Lead Member of the Examining Authority National Infrastructure Planning Temple Quay House 2 The Square Bristol BS1 6PN Our ref: AN/2024/135611/04-

Order Granting Development Consent for the Tillbridge Solar Project (EN010142) - Examining Authority's second written questions.

Q2. 14.1 Question for the Applicant and the EA on the topic of Reservoir Flood Risk.

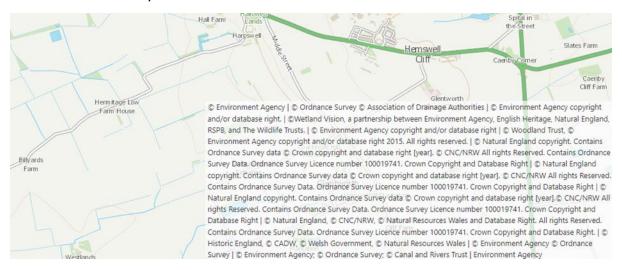
We also note the applicant describes it as a square reservoir. We have located a reservoir which seems to fit this description in Figure 10-1 of the Environmental Statement (Surface Water Features and Their Attributes). It is marked by a yellow circle with a black border in the North East corner, just South West of Hemswell. We

have calculated this to have Grid Reference SK9143589764. See blue square on Western side of map extract below.

The Environment Agency holds records of large, raised reservoirs holding 25,000 cubic metres or more of water above natural ground level. We have checked and this reservoir is not included on our records. If the reservoir does have a capacity over 25,000 cubic metres the reservoir should be registered with the Environment Agency.

The area of the reservoir, as measured from Ordnance Survey mapping, appears to be approximately 11471.68 m2 so it would need to have a height of around 2.5m to take it over the 25,000m3 threshold.

As the reservoir is not included in our records, it has not been included in the national reservoir breach mapping project. Therefore, the statement by the applicant

that this reservoir has been included in the Environment Agency breach mapping is not correct.

The risk posed by this reservoir will depend on the quantity of water/liquid stored above the natural ground level of the land. We have made the applicant's consultants aware of our latest position and it is understood that they will commenting on this, including the capacity of the reservoir, in their reply to this question.
